# LSD Averill Addendum No. 1

## Narrative of Changes

<b>Project Name:</b>	Averill Elementary Renovation SO-1847	<b>Date:</b>	December 4, 2025
<b>Project Location:</b>	3201 Averill Dr Lansing, MI 48911	<b>Architect's Project #:</b>	25013568A
<b>Owner/Client:</b>	Lansing School District	<b>Attention:</b>	David Beckering
<b>Issued to:</b>	Beckering Construction	<b>Email:</b>	djb@beckering.com
<b>City/State:</b>	Grand Rapids, MI	<b>Zip:</b>	49548

ED100

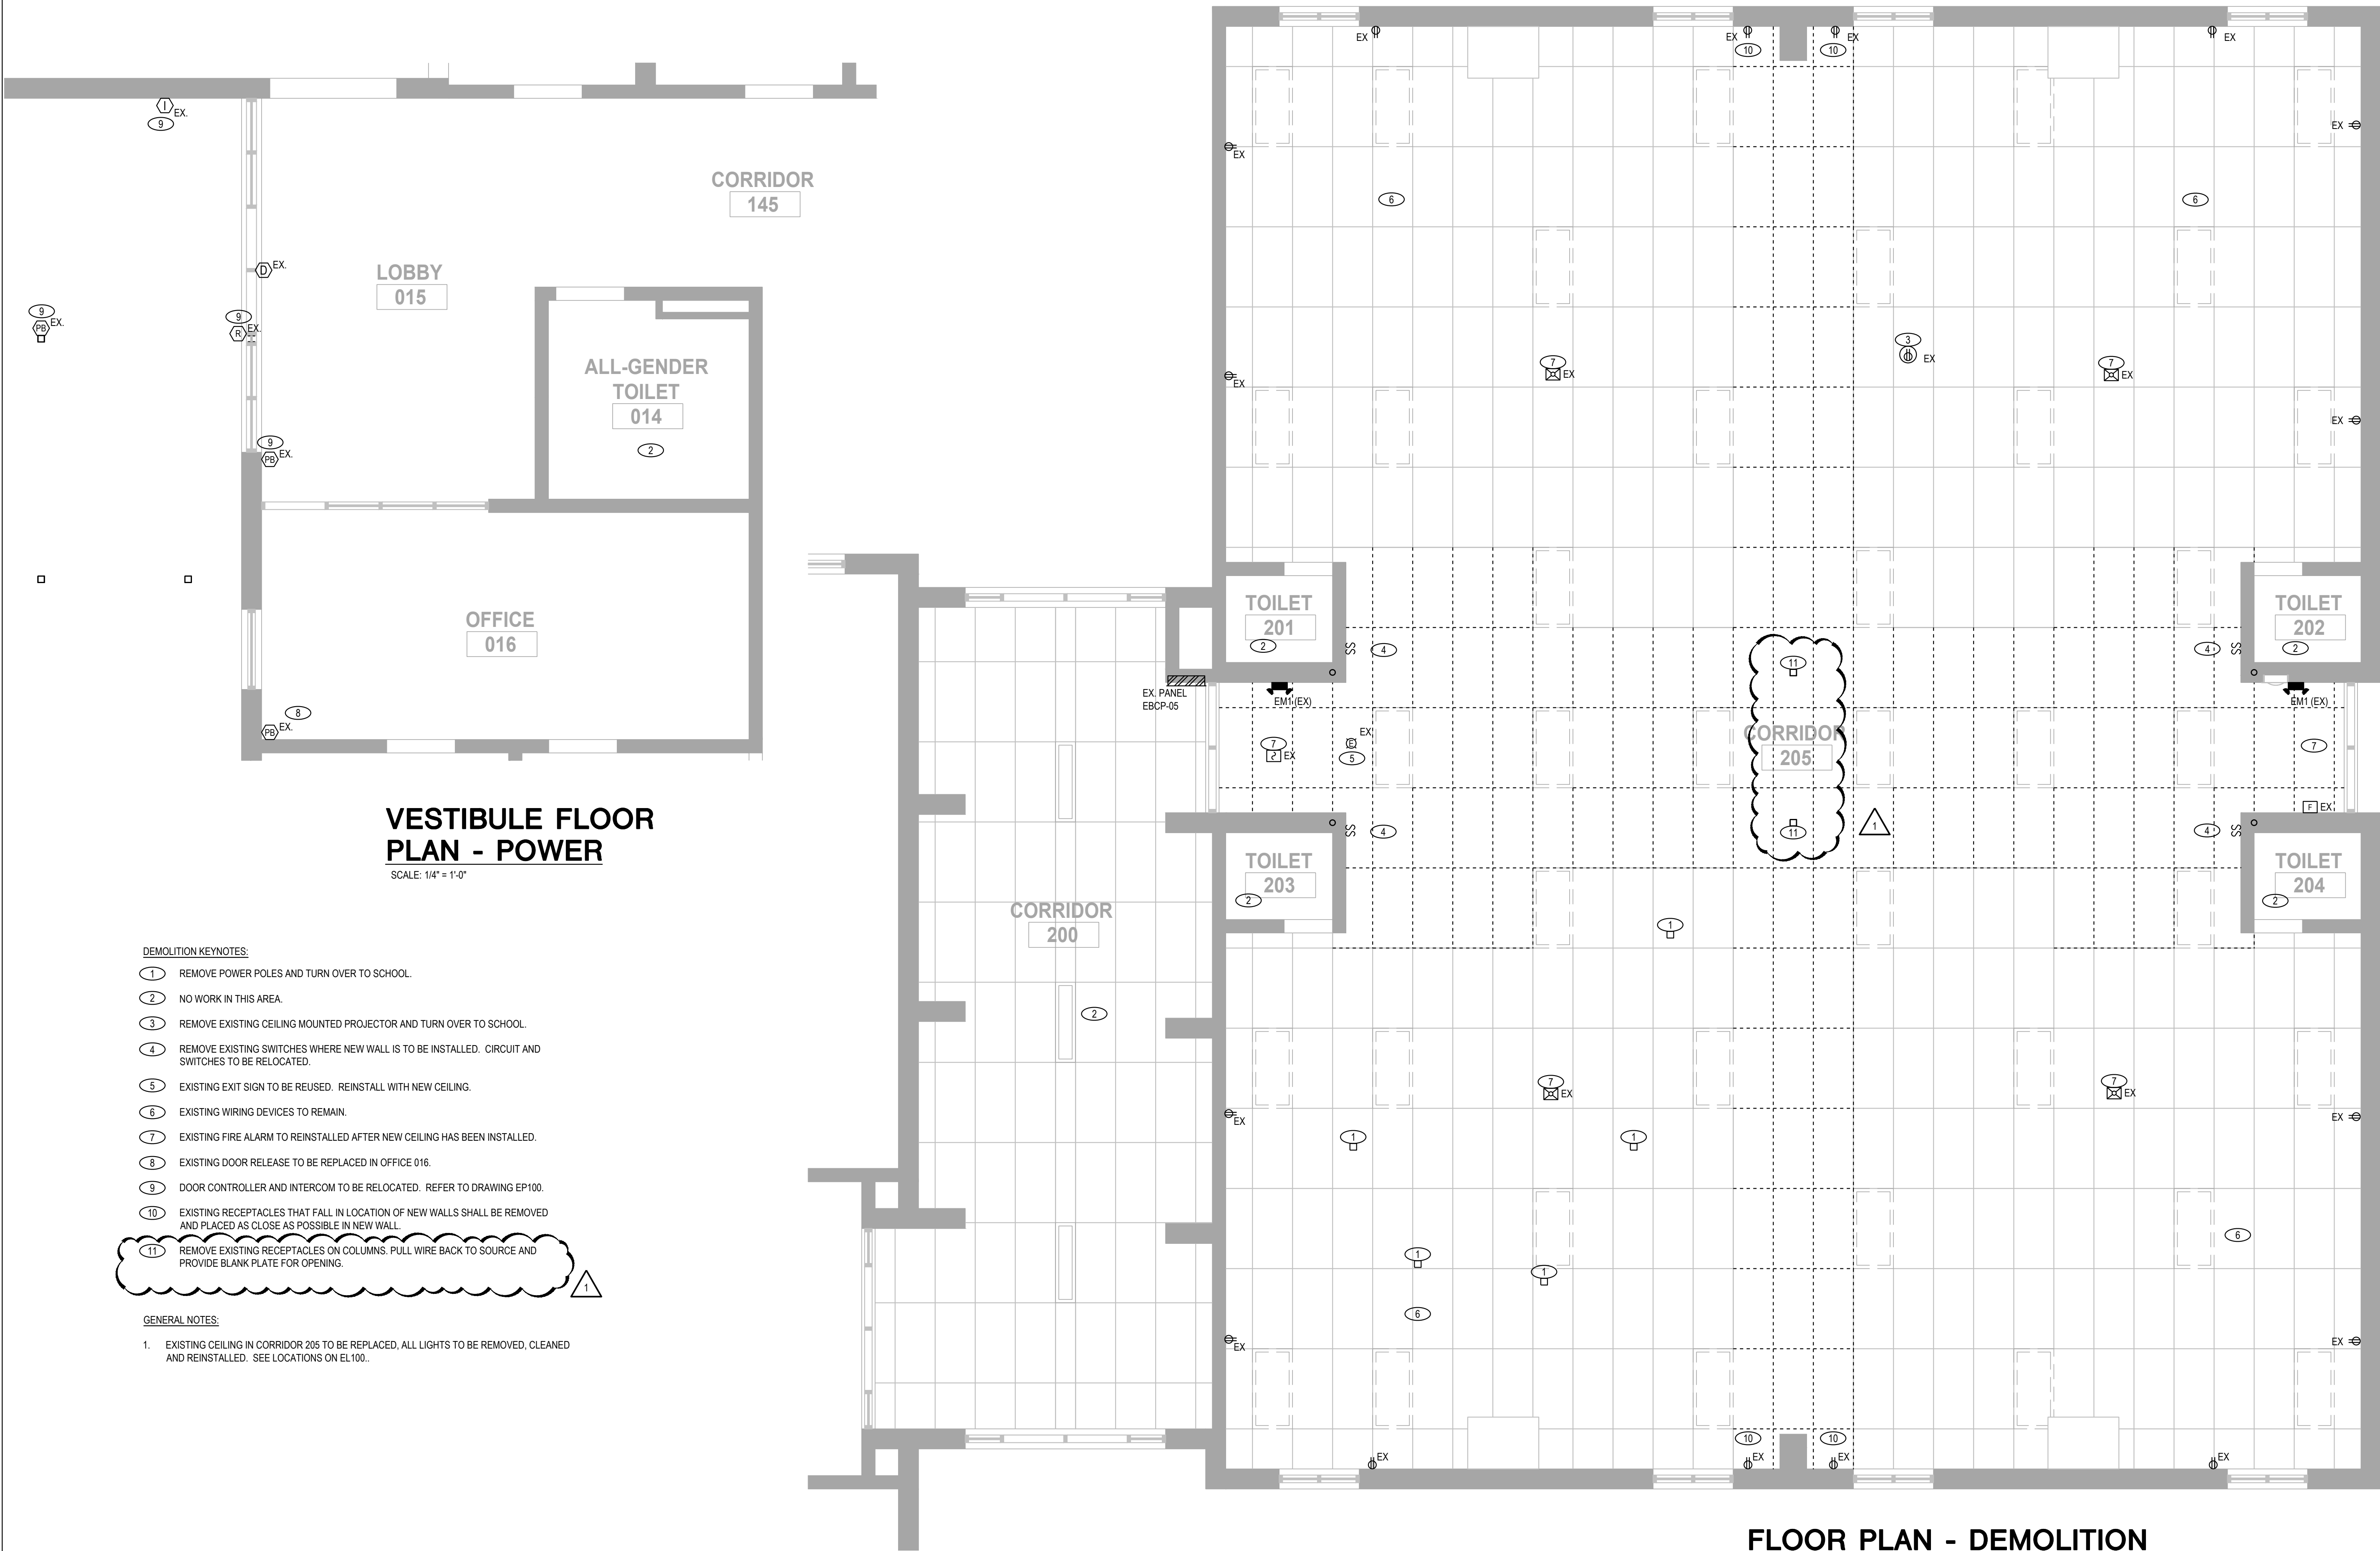
- Revised concrete hatching, refer to bubbled area on sheet AD010.
- Added additional concrete removal at sidewalk refer to bubbled area on sheet AD010 and keynote 7.
- Added additional concrete at sidewalk refer to bubbled area on sheet A010 and keynote 13.
- Composite fencing to be Trex Horizons, color woodland brown. Installed horizontally. Refer to sheet A011.
- Added keynote 20 to provide wood blocking for future upper cabinets in wall. See bubbled areas on sheet A101.
- Added specification for CPT-1 on sheet A141.
- Added dimensions to section 4/A301 for clarification.
- Added note 11 to include demo of existing receptacles on columns to be removed. Refer to sheet ED100.

- 1 REMOVE POWER POLES AND TURN OVER TO SCHOOL.
- 2 NO WORK IN THIS AREA.
- 3 REMOVE EXISTING CEILING MOUNTED PROJECTOR AND TURN OVER TO SCHOOL.
- 4 REMOVE EXISTING SWITCHES WHERE NEW WALL IS TO BE INSTALLED. CIRCUIT AND SWITCHES TO BE RELOCATED.
- 5 EXISTING EXIT SIGN TO BE REUSED. REINSTALL WITH NEW CEILING.
- 6 EXISTING WIRING DEVICES TO REMAIN.
- 7 EXISTING FIRE ALARM TO REINSTALLED AFTER NEW CEILING HAS BEEN INSTALLED.
- 8 EXISTING DOOR RELEASE TO BE REPLACED IN OFFICE 016.
- 9 DOOR CONTROLLER AND INTERCOM TO BE RELOCATED. REFER TO DRAWING EP100.
- 10 EXISTING RECEPTACLES THAT FALL IN LOCATION OF NEW WALLS SHALL BE REMOVED AND PLACED AS CLOSE AS POSSIBLE IN NEW WALL.

4 VESTIBULE WALL SECTION  
SCALE: 1" = 1'-0"

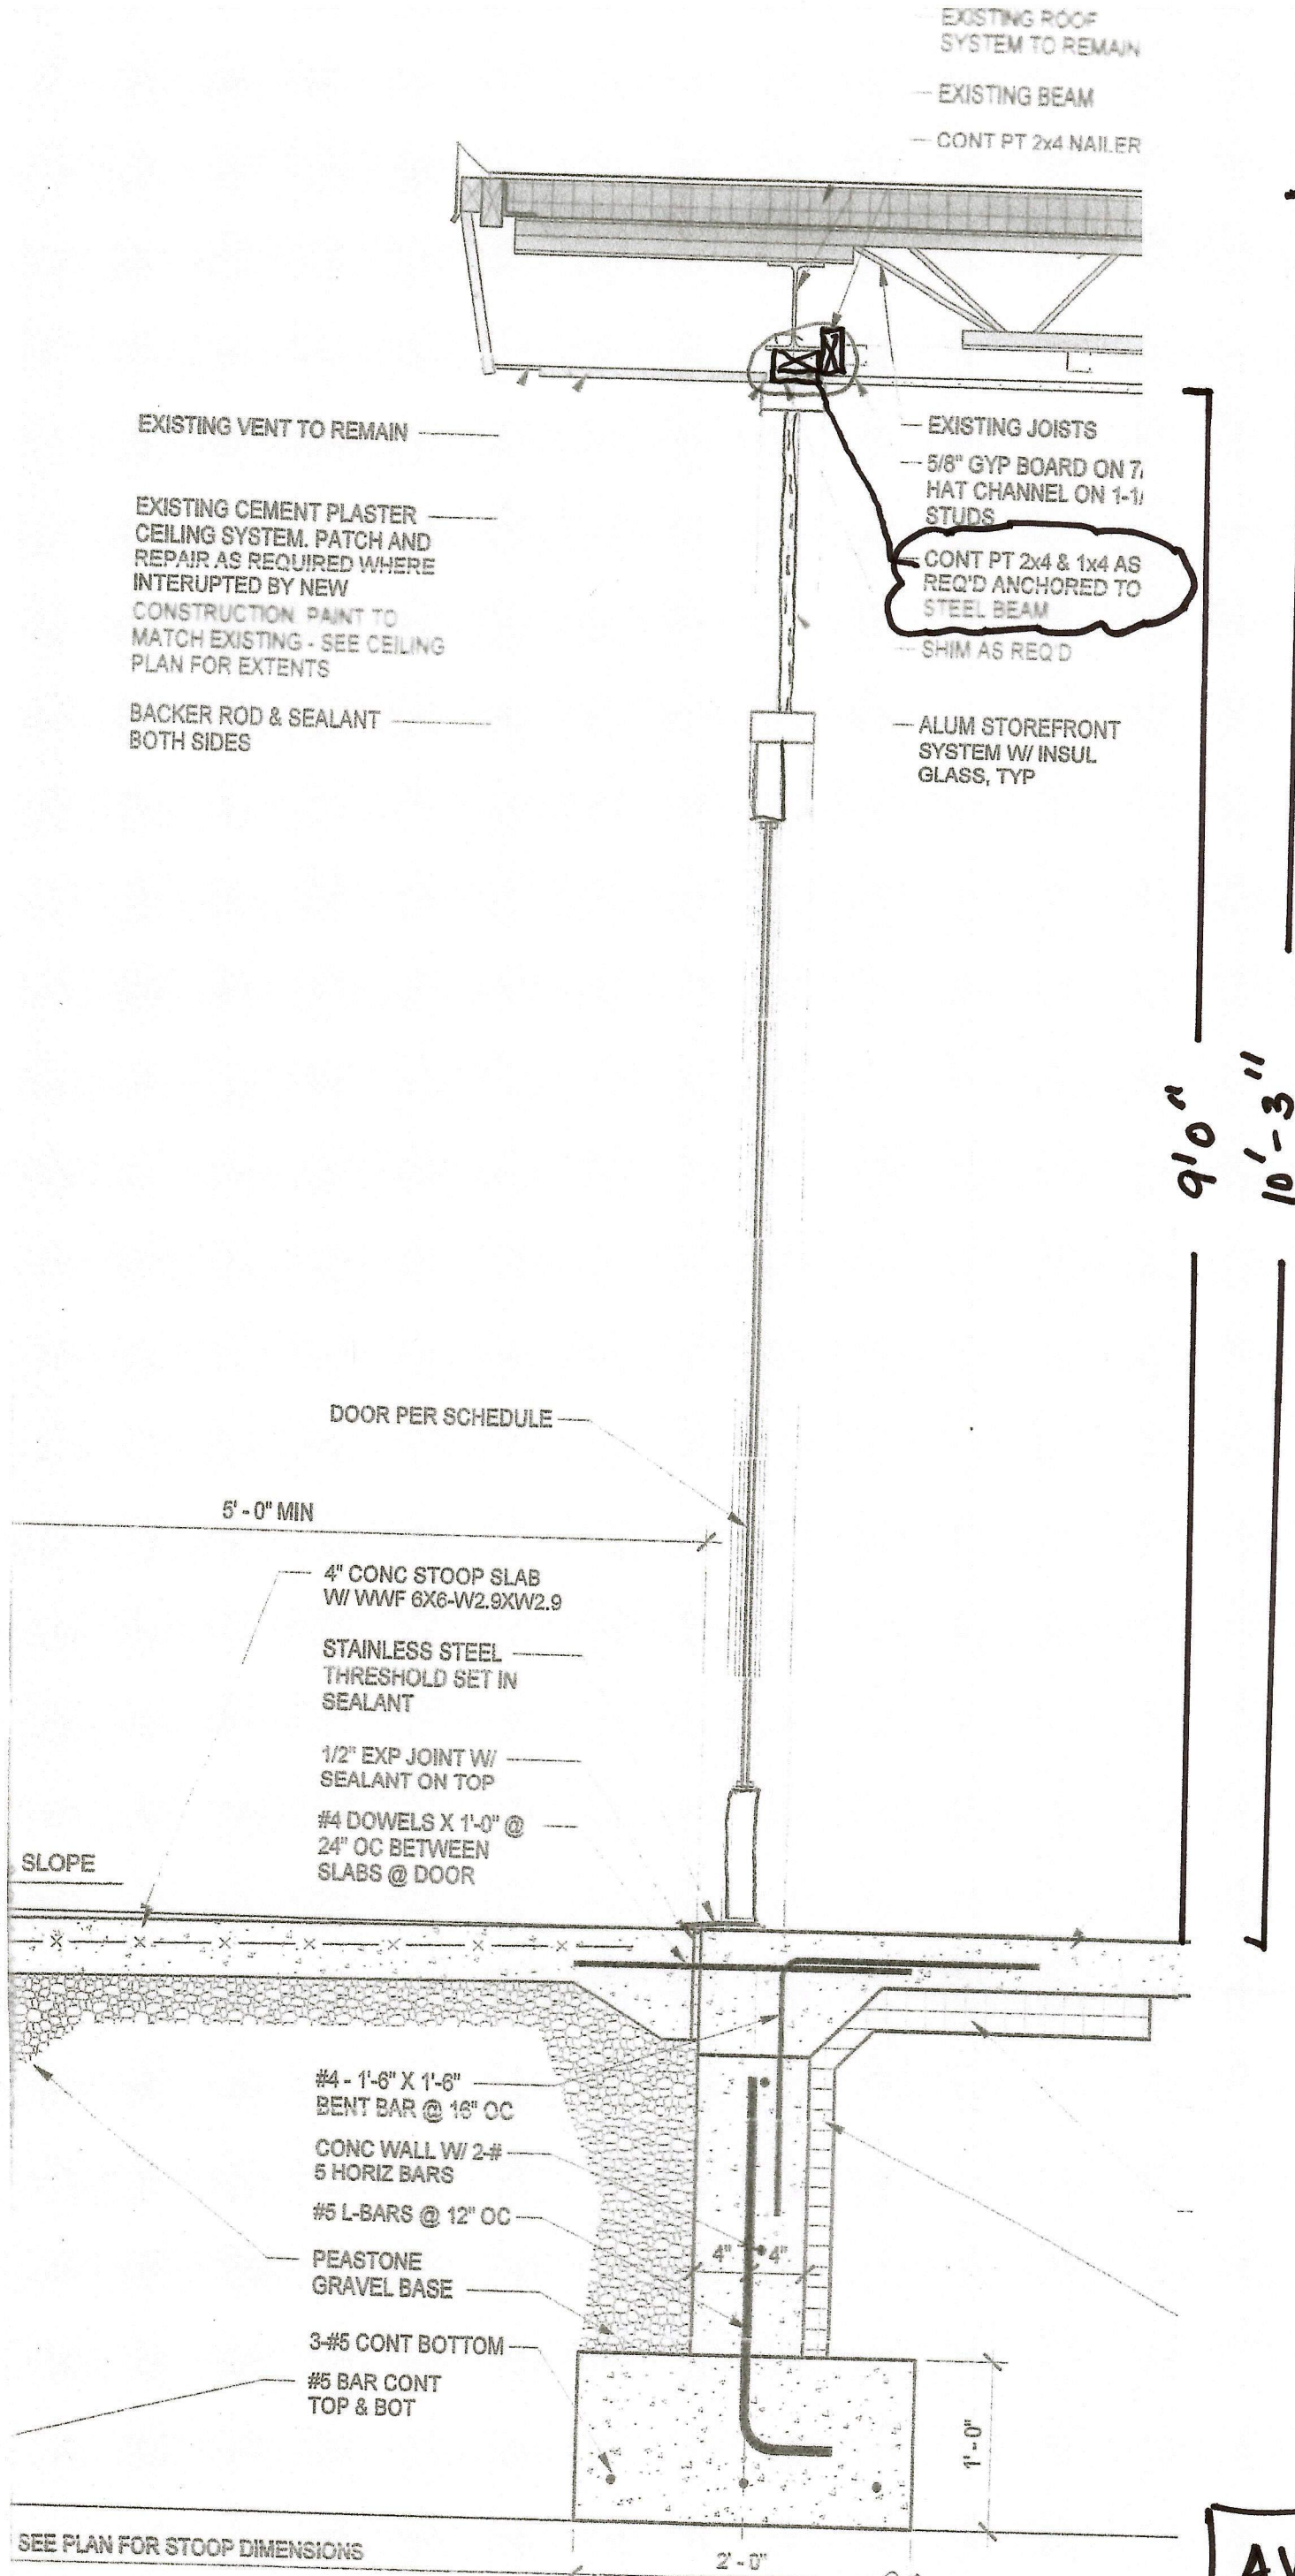
- As detailed on Sheet A121, the Vestibule 001 will get a new gypsum board ceiling.
- The existing soffit will need to be carefully cut at the line where the new aluminum storefront system and related wood blocking butt up to the soffit / ceiling. Cutting and demo of the existing soffit is covered by Division B – General Trades. Plaster soffit that remains in place must be patched by Division D contract. We assume this will take (1) man, (16) hours and miscellaneous patching material. See Sketch 'A'.
- See Sketch 'B' - Detail 4/A301, the roof deck scales to be 10'3" AFF and the ceiling scales to be 9'0" AFF.

- See Sketch 'B', existing plaster soffit must be carefully cut at the line where the new storefront system and related blocking butt up to the new ceiling / soffit.

AVERILL ELEM  
SKETCH 'A'

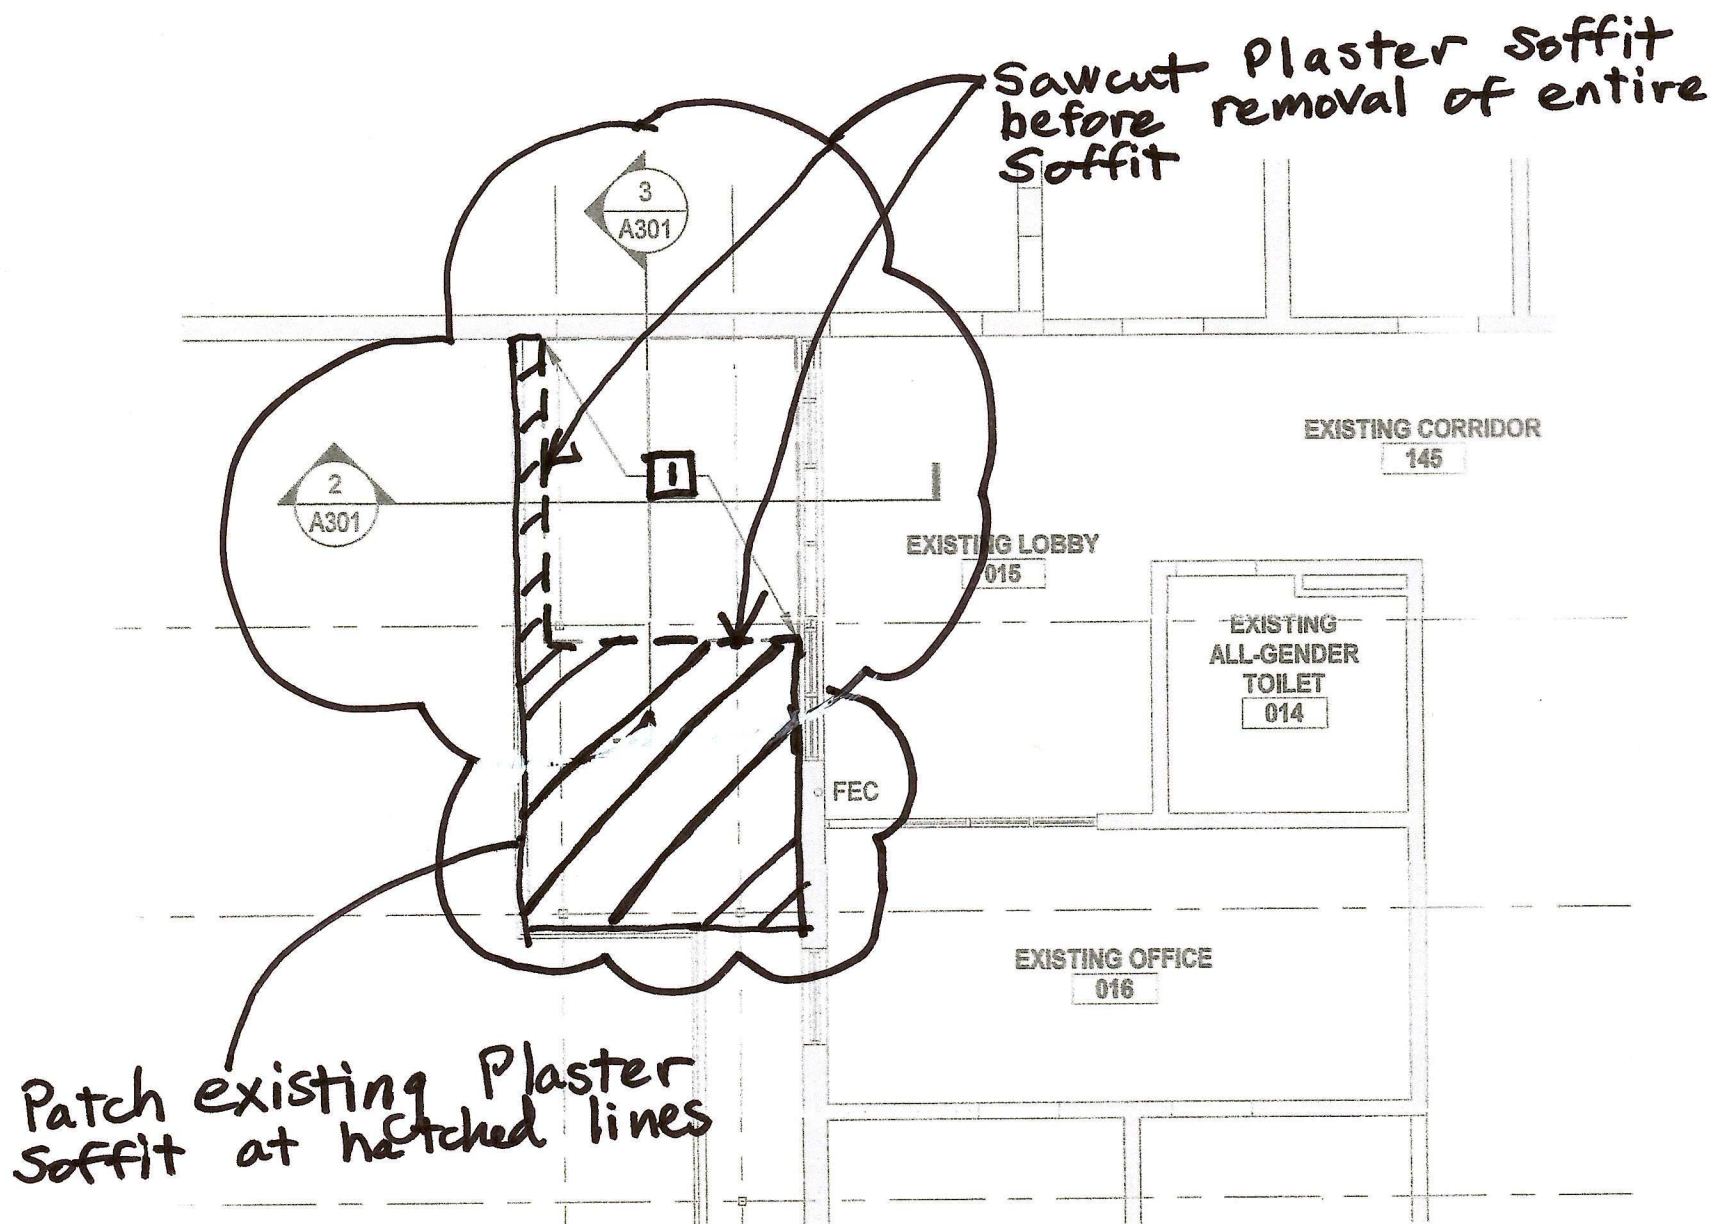
Key Note  
1 Remove existing Soffit

AVERILL ELEM  
SKETCH 'C'

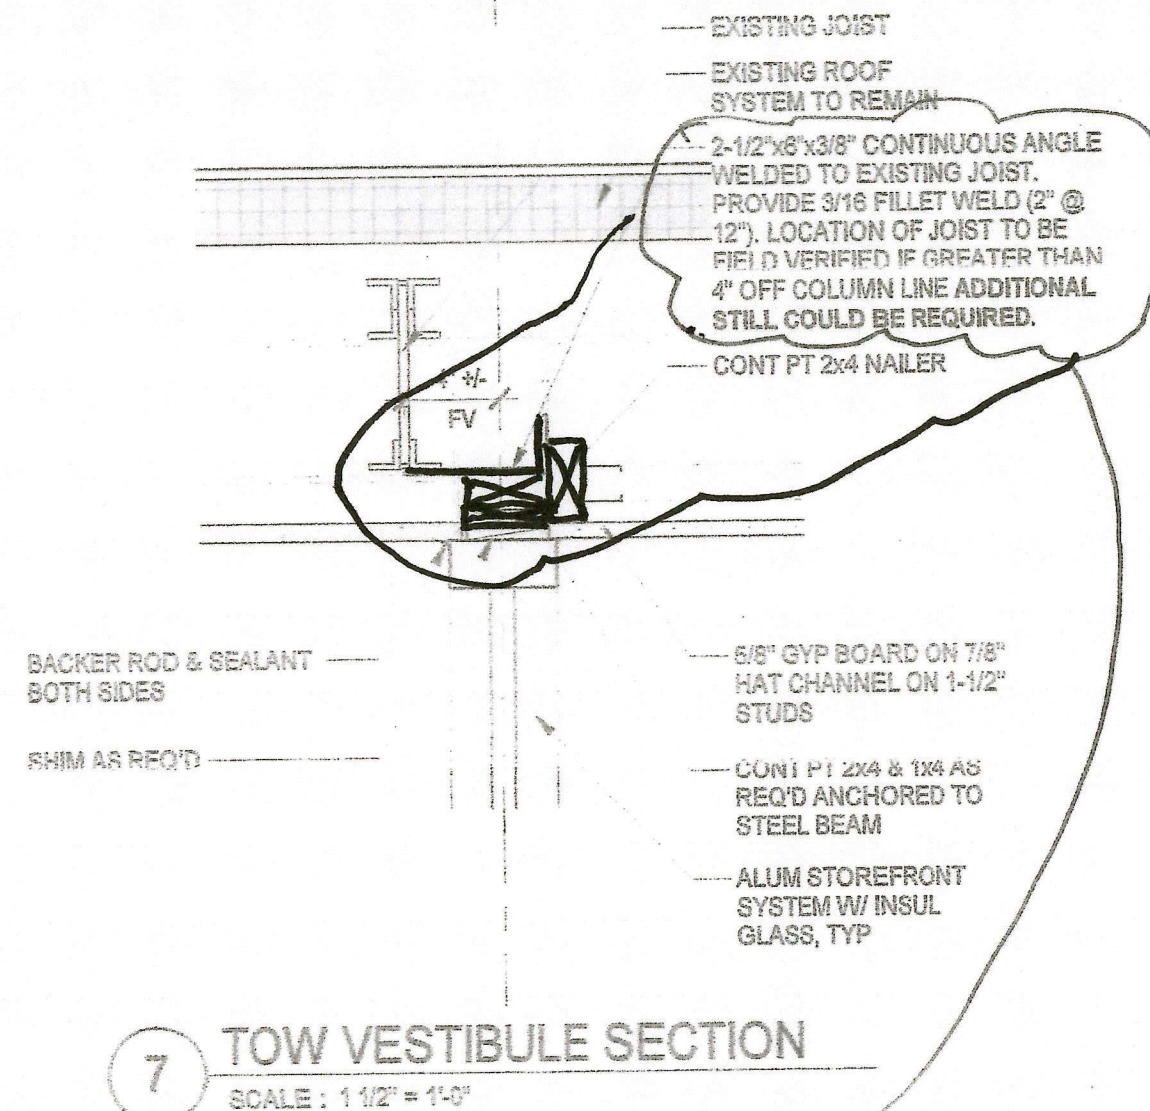
- General Trades - Division B also includes all required interior non-com wood blocking at classroom door frames, (12) classroom marker tackboards, (8) 8'0" long corner guards and blocking for upper and lower cabinets along (1) 15'6" wall in each classroom. See Sketch 'C'.

- Inpro corner guards are covered in the General Trades - Division B. There are (8) corner guards as noted on Sketch 'C'.
- All plywood blocking at steel columns is included in General Trades - Division B.

- Supply and installation of the steel angle as noted in Detail 7/A301 is included in General Trades – Division B. See Sketch 'C'.

There is 12 lf of this Angle Detail
